Proceedings of the Madras Government, Public Works Department,
8th May 1871.

I HAVE the honour to report upon the Subsidiary Jail and out-houses at Nangunery, 1st Range, Tinnevelly, carried into execution under the supervision of Mr. Sub-Engineer Colquhoun.

Subsidiary Jail at Nanguneri in the Tinnevelly District.

Passing orders on papers relating to the faulty construction of the Subsidiary Jail at Nanguneri in the Tinnevelly Dt.

Plan of a Subsidi-
-ary Jail & out houses
at Nanguneri Rs
4,420

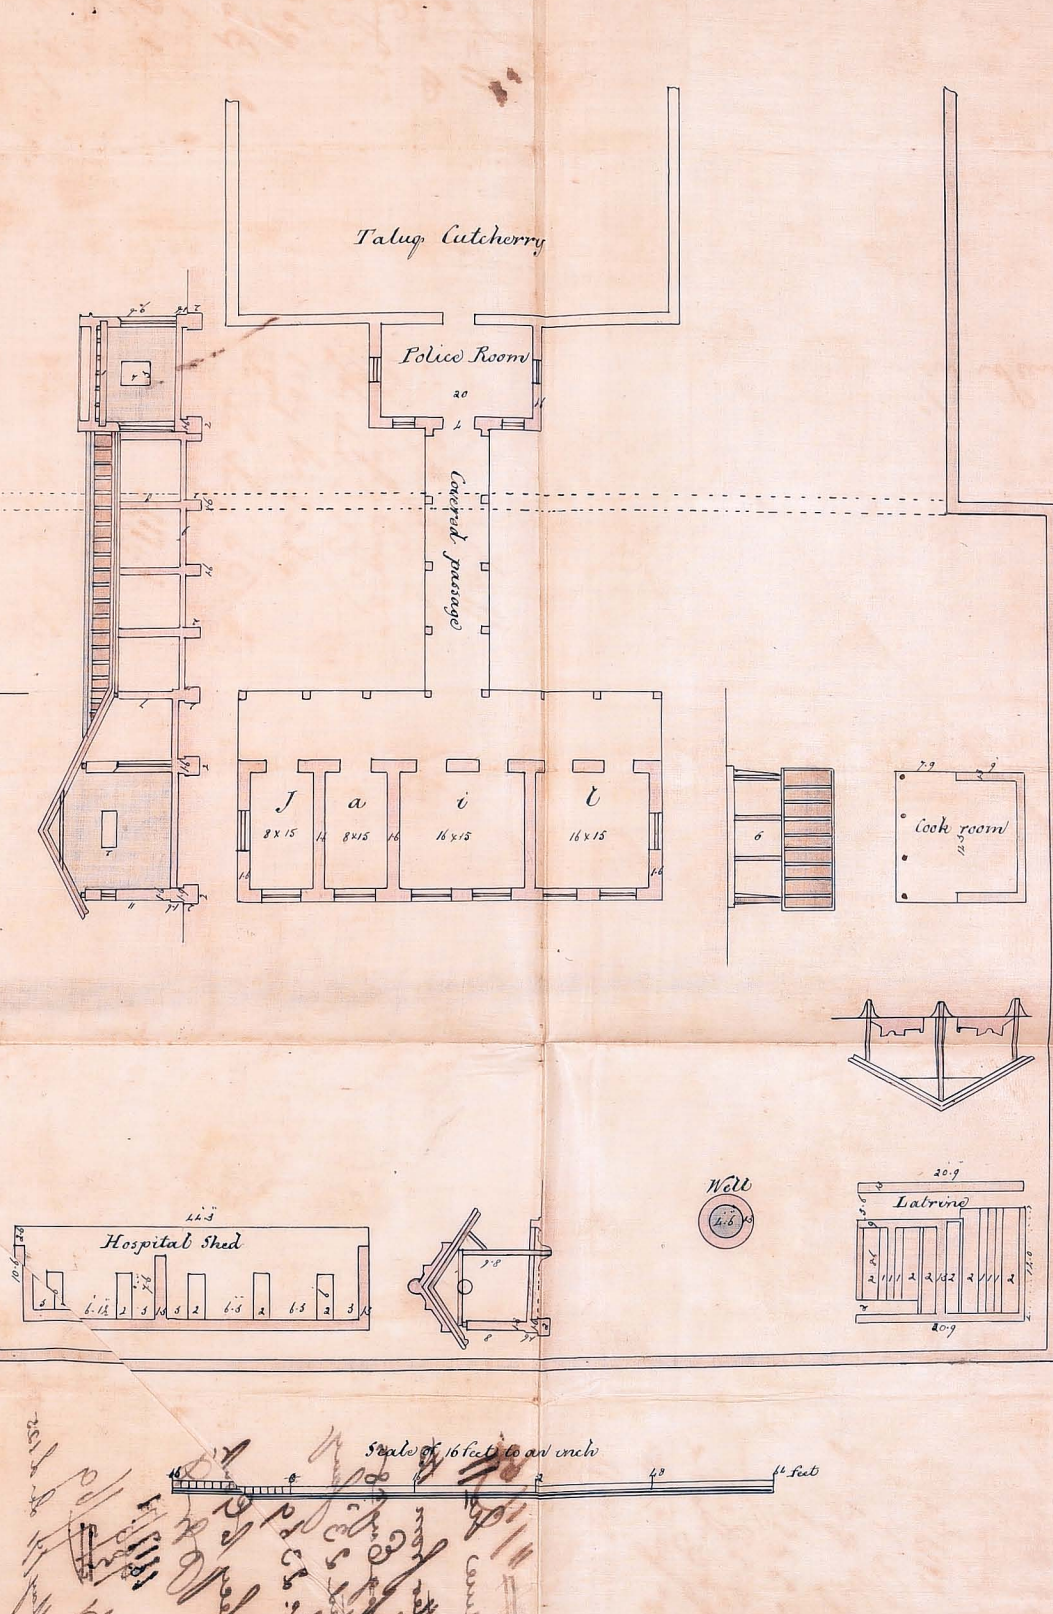
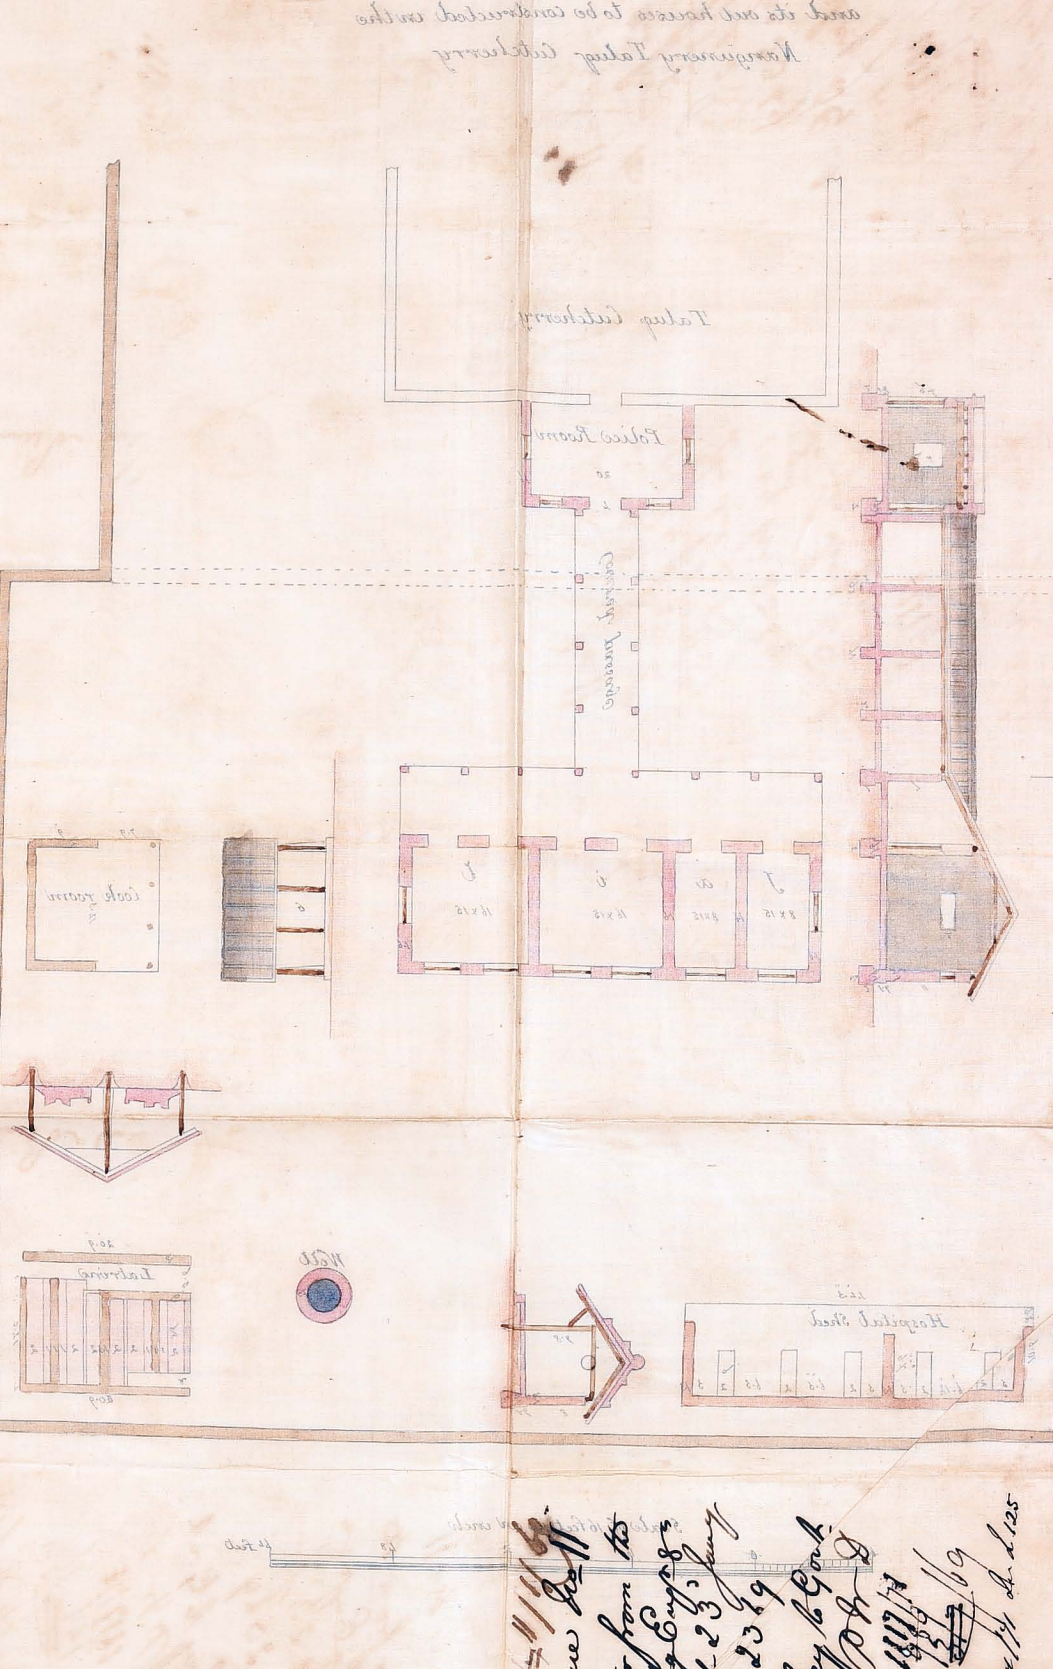
I remark that the plan of the open Hospital is commented upon. I always thought that plan erroneous. I think it should be revised.

It will here be noticed that the design of the open Hospital attached to Sub Jails is thought to be unsuitable owing to the liability of the inmates to exposure. The question of effecting such modifications in the standard plan as are calculated to afford complete protection from the weather will accordingly be considered in the Judicial Departt.
